February 1, 1993

RE: - HPS Post Certification Modification.

Per your instructions, I have enclosed drawings and tables indicating the changes to the wetland impacts and wetland mitigation associated with the Hardee Power Station to Lee Substation. These changes involve a variety of items including eliminating errors on drawings, replacing corduroy roads with culverts or replacing culverts with corduroy roads, adding culverts in roadside ditches where alternate access was not available, and modifying the restoration and creation areas to comply with SWFWMD and FG&FWFC requirements. The information for culvert sizing and changing corduroy roads to culverts has been submitted and approved by SWFWMD. Under condition XXXV C. 1. c. the culvert/corduroy road activities have been determined by SECI to be minor field changes and therefore may not require a modification to our post certification approvals. The changes to the restoration/mitigation area are relatively minor changes as required by other agencies and therefore may or may not require DER approval.

FIGURE 4-A
SLOUGH 3: PLAN VIEW OF WEIR

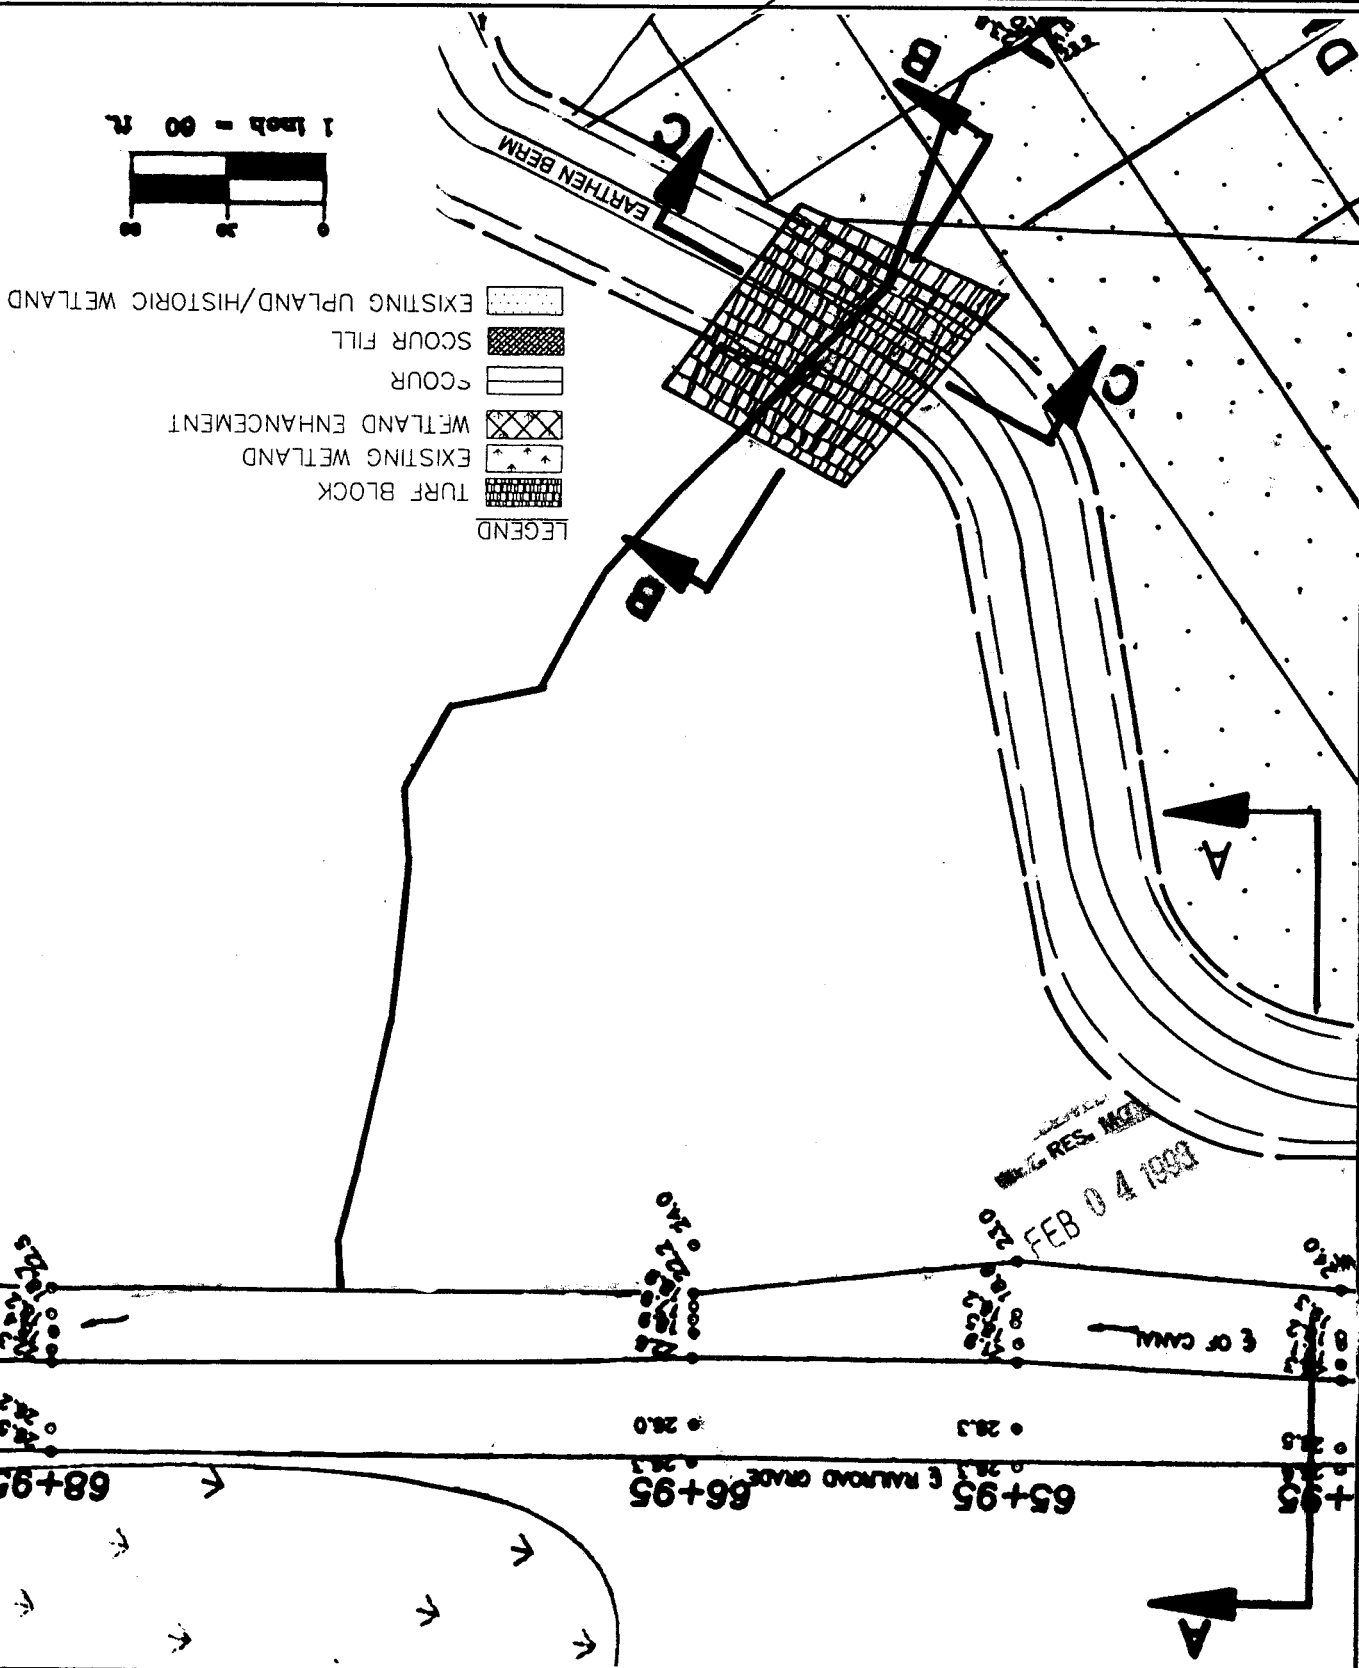
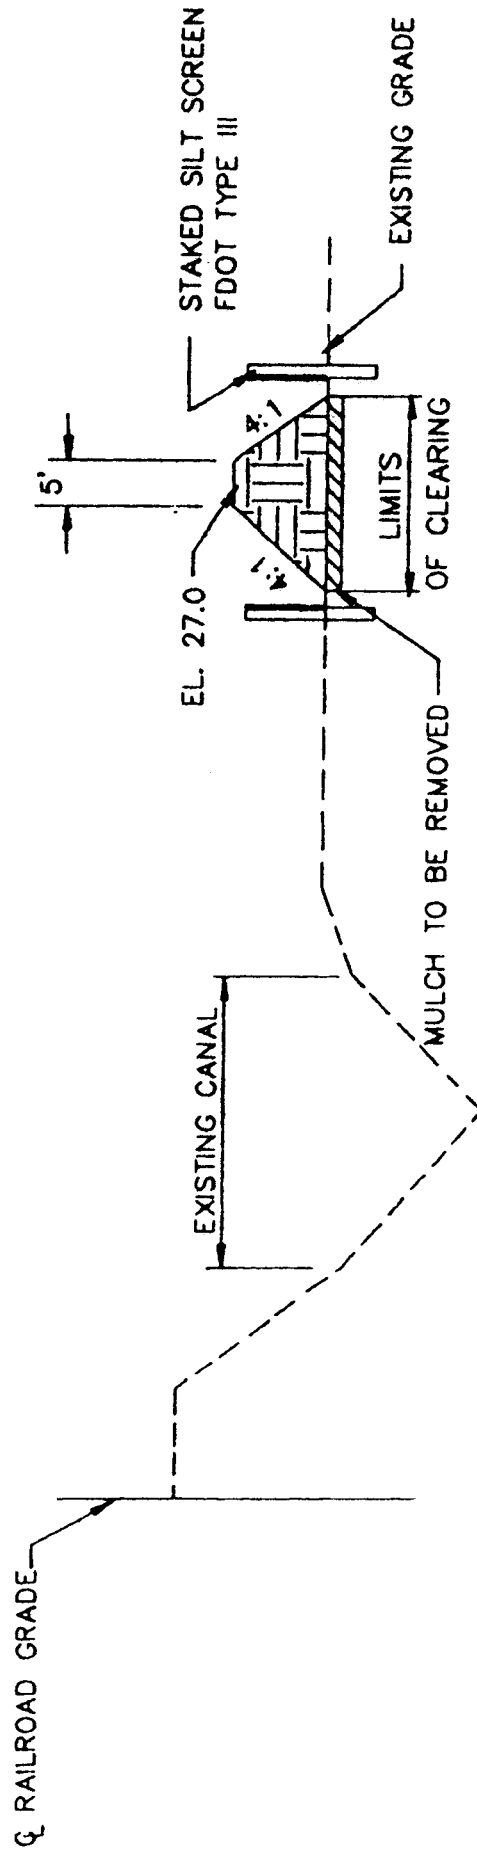
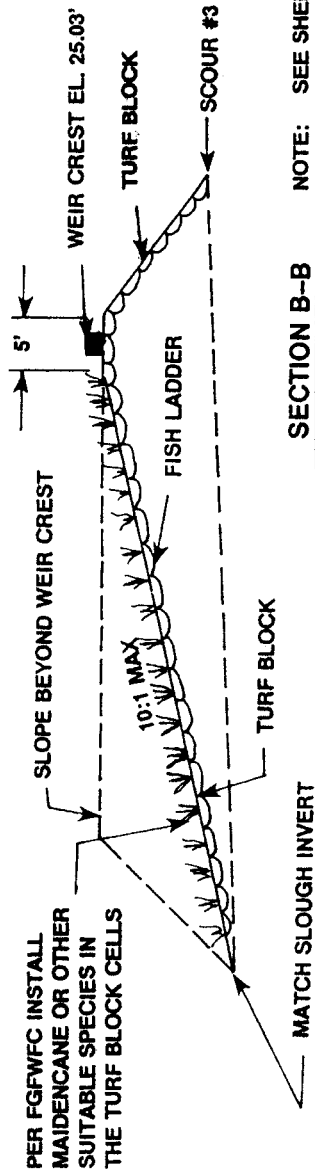
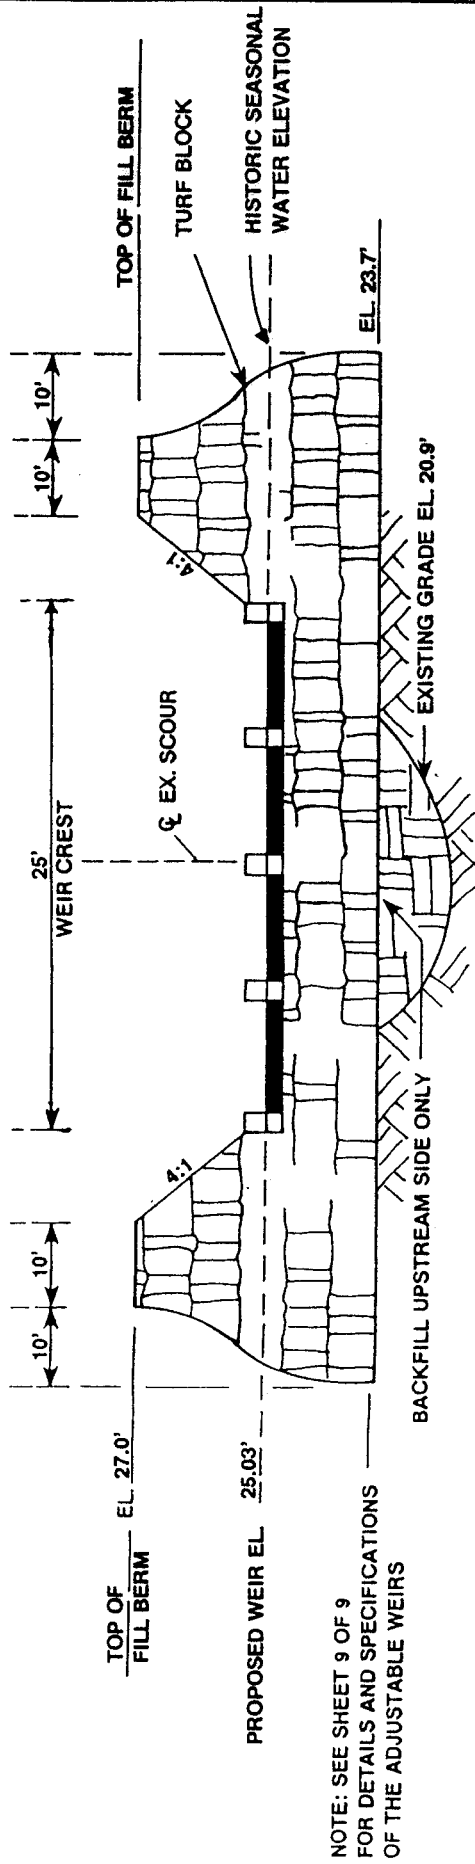
- . The berm in Slough #3 was required by FG&FWFC to be located away from a pine area which was believed to contain fox squirrels. This change decreased the area to be restored by 5.12 acres.
- . Slough 3 weir elevation was changed from 24.2 NGVD to 25.03 based on additional data from piezometers and an on-site staff gauge.
- . Due to the SWFWMD the creation area has been modified from 20.0 acres to 21.5 acres with the connections only to slough 2. Numerous details have been modified such as topography, location of type for type areas, sizes and species to be planted, numbers of plants to be planted, and grades and areas to be planted with specific species. Since this area was not considered to be mitigation by DER, these changes should be insignificant.
